To: All U.S. and Canadian Volvo Retailers
Subject: Service Action S79852

**Service Action S79852: Rear Air Spring Dust Cover Clamps
Model Year 2016 XC90 Models with Air Suspension**

Title	Rear Air Spring Dust Cover Clamps	Page	1 (8)
Action	Replacement	Operation number:

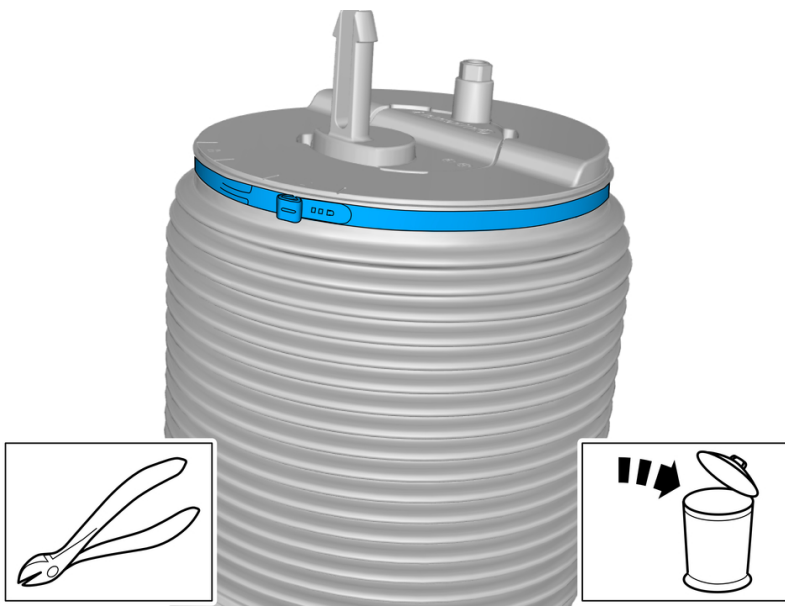
Remove the cable tie(s).

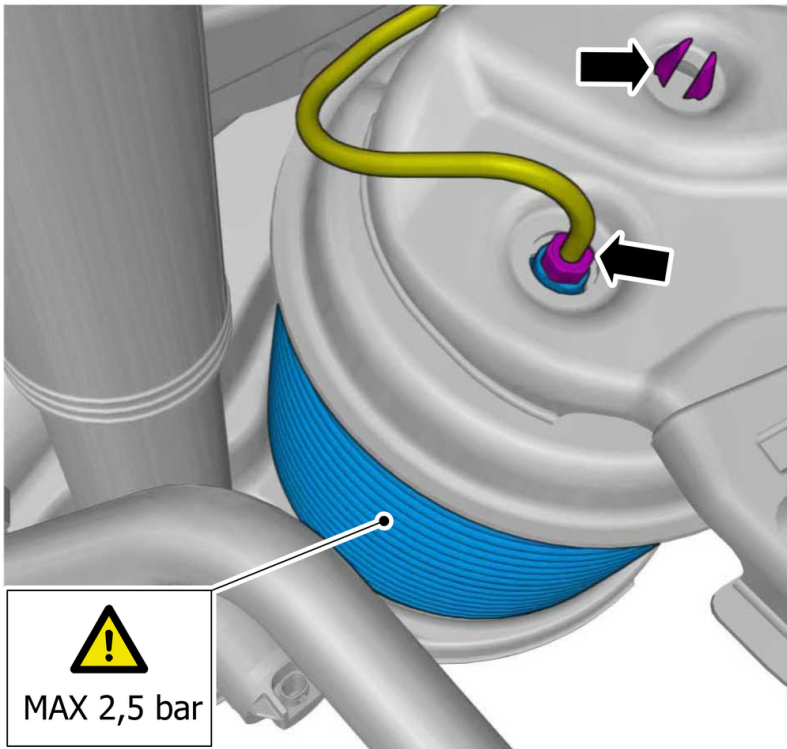
Applies to the right-hand side

Caution! Make sure that the component is positioned correctly.

On both sides.

Note! Make sure that a new clamp is installed.

Special Tool: T9814201, Lock grip pliers
Tighten the cable tie.
